By Steve Huntoon

## Cue More Pixie Dust

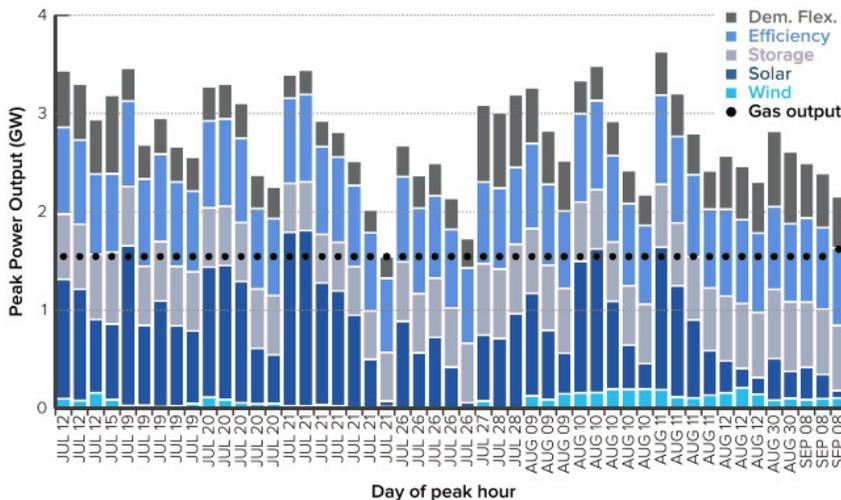
The second major flaw is a variation of the pixie dust problem I've written about before. This is apparent from examining RMI's Figure 6 reprinted below:

Looking at the July 20 hours, storage is drawn down, and yet the next day, storage is assumed to start off fully charged to provide maximum capacity for the seven peak hours that day. Where did the electric energy come from to charge the batteries for July 21?

At one point (page 29), RMI says, "In all cases, the CEP generates the energy needed to charge the battery storage." But on the next page, it says it is only considering (emphasis RMI's) "the economics of marginal additions," apparently meaning that traditional fossil generation is assumed to be recharging the batteries.<sup>6</sup> Indeed, that is the only realistic

A last note: Look again at Figure 6 below, and focus on the last hour of July 21. RMI is showing that the equivalent of a 1.5-GW gas generator would be matched by: zero wind and a negligible amount of solar; batteries charged with traditional fossil generation; and huge amounts of DR and EE, neither of which are unique to a renewables/battery scenario. In other words, renewables are contributing virtually nothing to matching the 1.5-GW gas generator.
